FIELD OBSERVATION REPORT

Central Hardin High School, Cecilia, KY

2019111 - CA8

Report No: 50

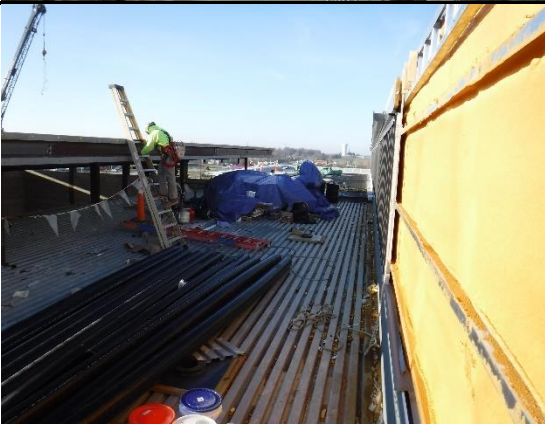
Item No.	Location	Description/Correction	Image	Action
4	Area B – LMC Roof	Erectors were fastening the metal roof deck to the steel frame.		Refer to the SPIN report for the attachment of the deck.
5	Area B - LMC.	Masons were laying concrete block between the steel frame. The open areas are for windows.		Refer to the SPIN report for reinforced masonry.
6	Area F.	The administrative area was being formed with concrete block walls.		Use cold weather precautions when laying masonry in winter conditions.
